Work Order ID 160309

Item Name: AS350/AS355 Quick Release Heli-Utility-Basket™, Short, Heavy Duty Lid

DART SERVICE INSTRUCTION

TO AMEND INSTALLATION INSTRUCTIONS D350-607-3 Rev.D,
INSTALLATION INSTRUCTIONS D350-607-4 Rev. C AND
INSTRUCTIONS FOR CONTINUED AIRWORTHINESS ICA-D350-607 REV. 6

FIGURE 1: INSTALLATION OF D4775-041 FWD STRUT

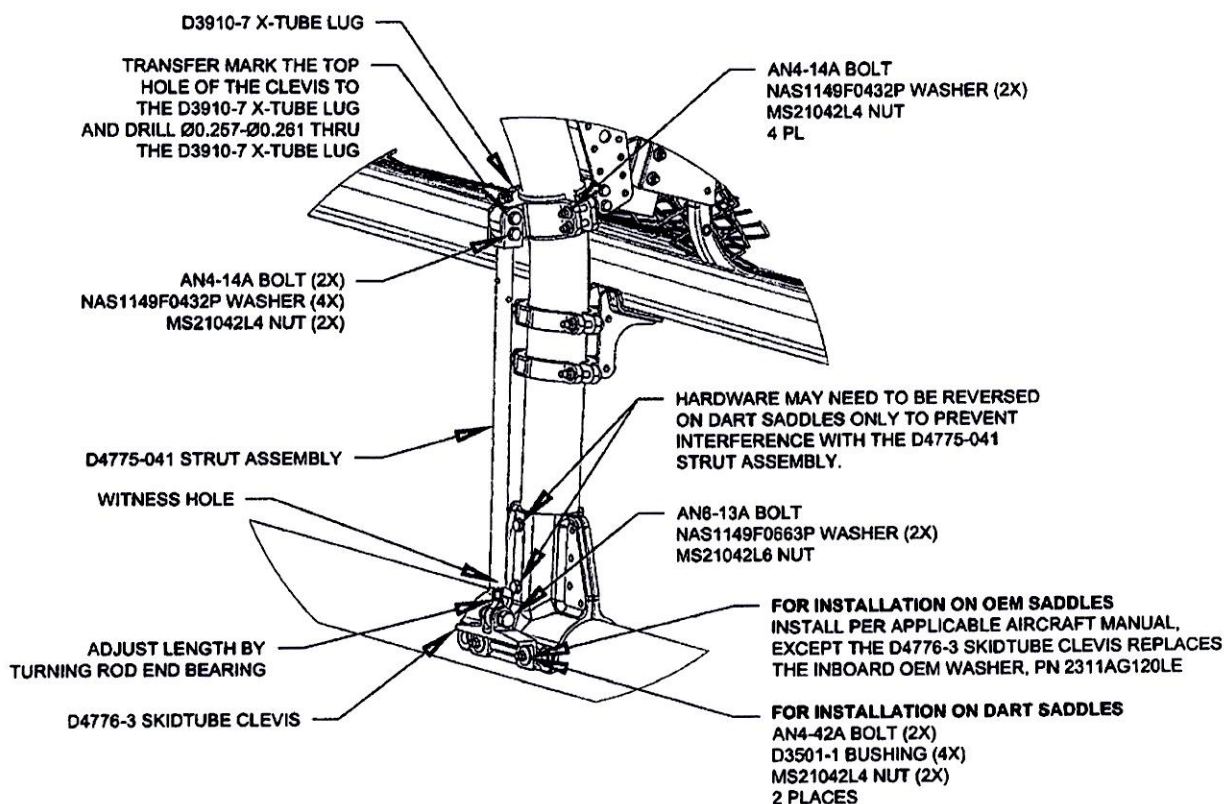
- 3.1 Substitute the Forward Lower D3910-5 X-Tube Lug with the D3910-7 X-Tube Lug as shown in Figure 1.
- 3.2 Install the forward D4775-041 Strut Assembly. Transfer mark from the upper hole on the clevis of the D4775-041 Strut Assembly to the D3910-7 X-tube Lug and drill thru the lug $\varnothing 0.257$ - $\varnothing 0.261$ as shown in Figure 1. Touch up chemical conversion coating per MIL-DTL-5541. Check the witness holes located at the bottom end of the D4775-041 Strut Assemblies to ensure that the thread from the rod end extends past the witness hole.
Torque MS21042L4/-4 nuts to 50-70 in-lbs (5.7-7.9 N-m). Torque MS21042L6/-6 nuts to 160-190 in-lbs (18.1-21.5 N-m).
- 3.3 Complete the installation in accordance with Installation Instructions D350-607-3 Rev. D or D350-607-4 Rev. C.
